**Contribution targets:**

**Action Items 26 and 27:**

## 144.3 Multipoint Control Protocol (MPCP)

**1) Replace figure 144-3 with the following block diagram:**

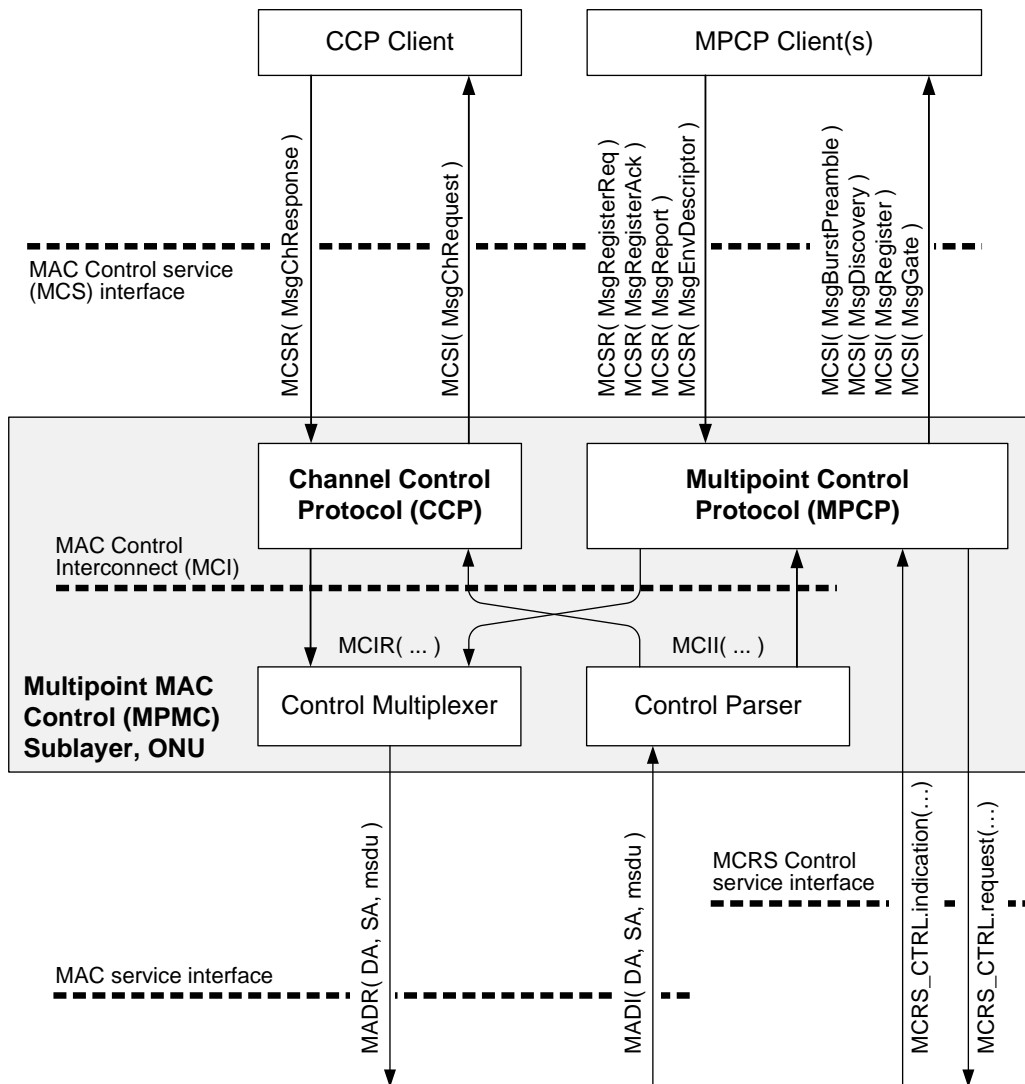
Editor’s Note (to be removed prior to publication): Action item for Glen come up with a new way to show MPCP and CCP for Figure 144-3. This will be submitted as comment against next version of a draft.

**Figure 144-x – OLT Multipoint Control Protocol (MPCP) functional block diagram**

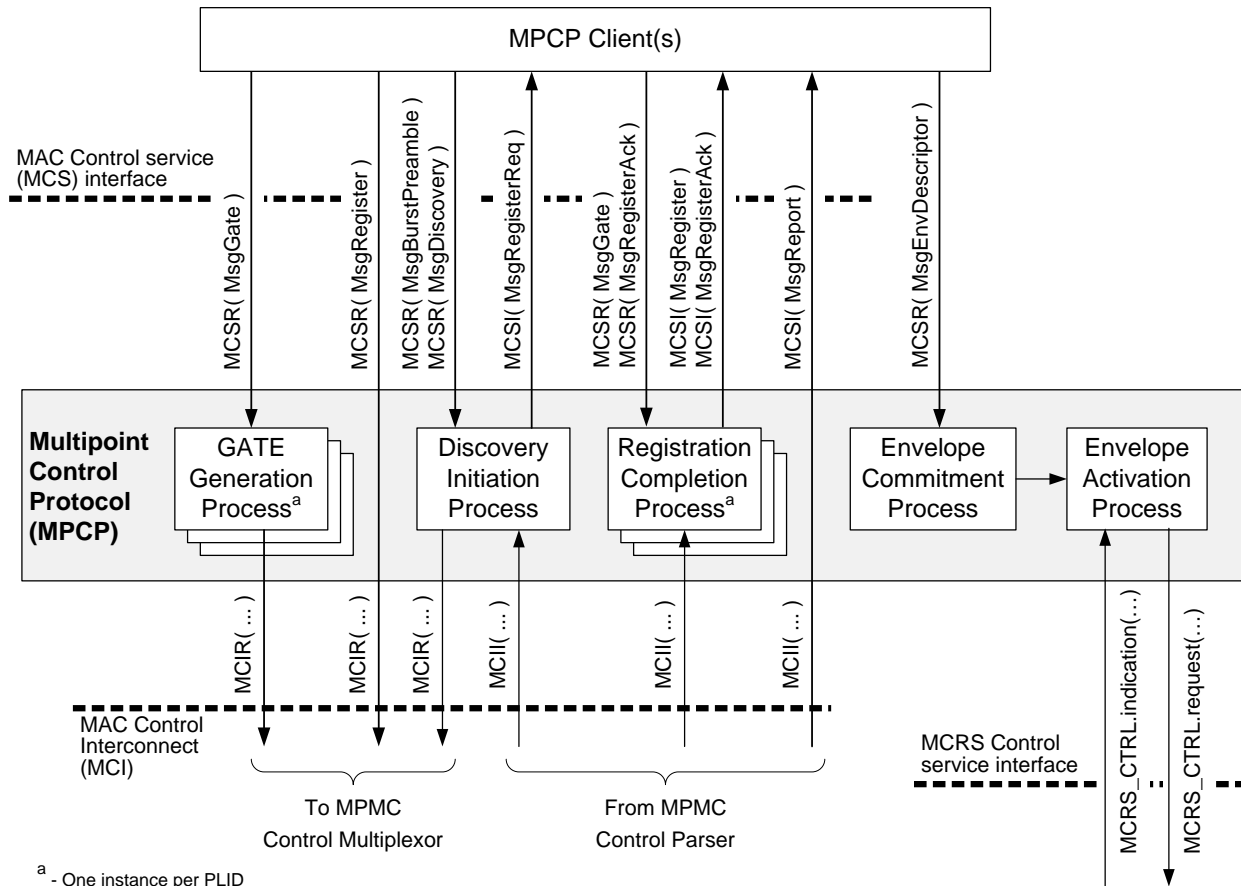
3) Renumber the existing subclause 144.3.1.2 into 144.3.3 and update "TBD" as shown below.  
 Insert new text into subclause 144.3.1.  
 Insert new subclauses 144.3.1.2 and 144.3.2.

Figure 144-x illustrates a functional block diagram of the Multipoint Control Protocol (MPCP) for the OLT. The MPCP in the OLT includes the following processes:

- GATE Generation Process (see 144.3.6.7)
- Discovery Initiation Process (see 144.3.5.6)
- Registration Completion Process (see 144.3.5.7)
- Envelope Commitment Process (see 144.3.6.9)
- Envelope Activation Process (see 144.3.6.11).

In the OLT, as separate instance of GATE Generation Process and a separate instance of Registration Completion Process is created for each registered ONU (PLID, see 144.3.2).

Figure 144-y – ONU Multipoint Control Protocol (MPCP) functional block diagram

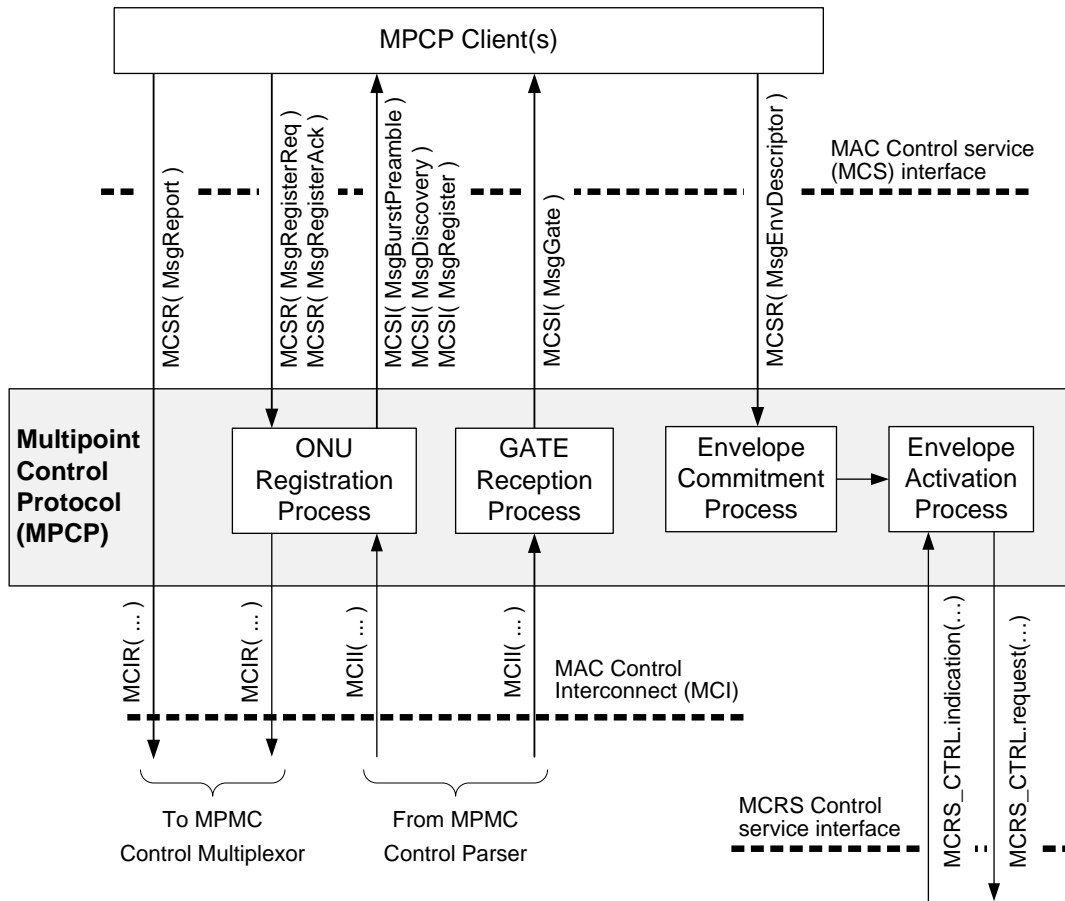
Figure 144-y illustrates a functional block diagram of the Multipoint Control Protocol (MPCP) for the ONU. The MPCP in the ONU includes the following processes:

- ONU Registration Process (see 144.3.5.8)
- GATE Reception Process (see 144.3.6.8)
- Envelope Commitment Process (see 144.3.6.10)
- Envelope Activation Process (see 144.3.6.11).

**Figure 144-u – OLT Channel Control Protocol (CCP) functional block diagram**

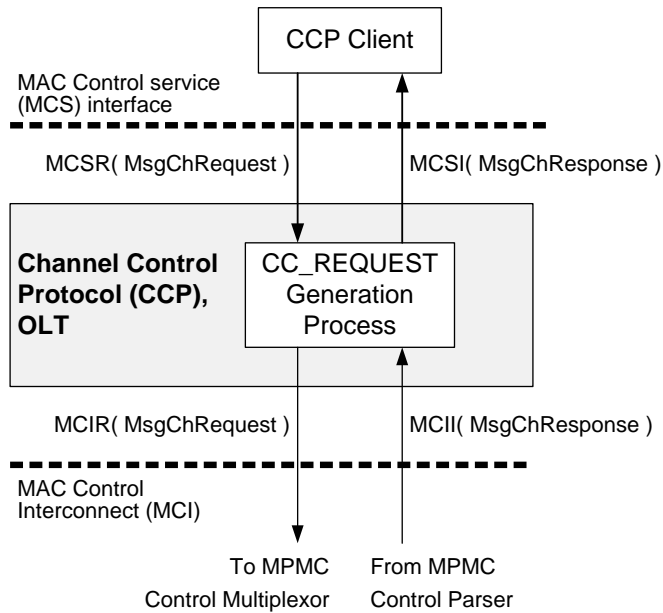
- 4) Renumber the existing subclause 144.4.1 into 144.4.2. Insert the following new section 144.4.1:

Figure 144-u illustrates a functional block diagram of the Channel Control Protocol (CCP) for the OLT. The CCP in the OLT includes the CC\_REQUEST Generation Process state diagram (see 144.4.3.6).

**Figure 144-v – ONU Channel Control Protocol (CCP) functional block diagram**

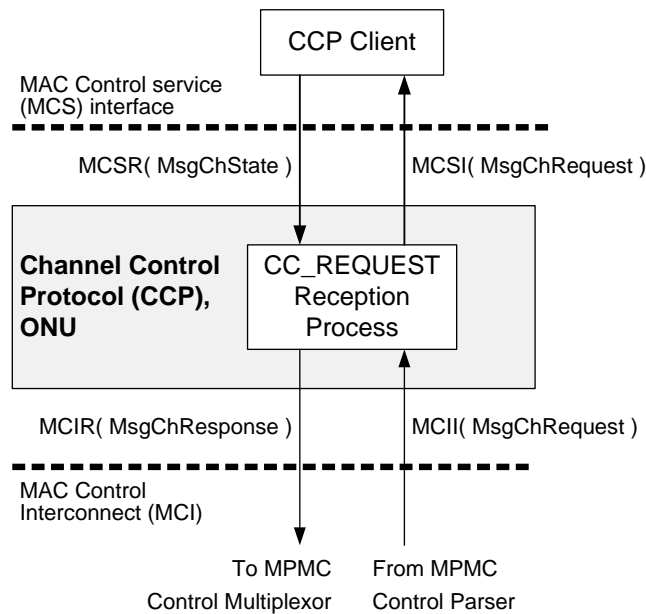
Figure 144-v illustrates a functional block diagram of the Channel Control Protocol (CCP) for the ONU. The CCP in the ONU includes the CC\_REQUEST Reception Process state diagram (see 144.4.3.7).
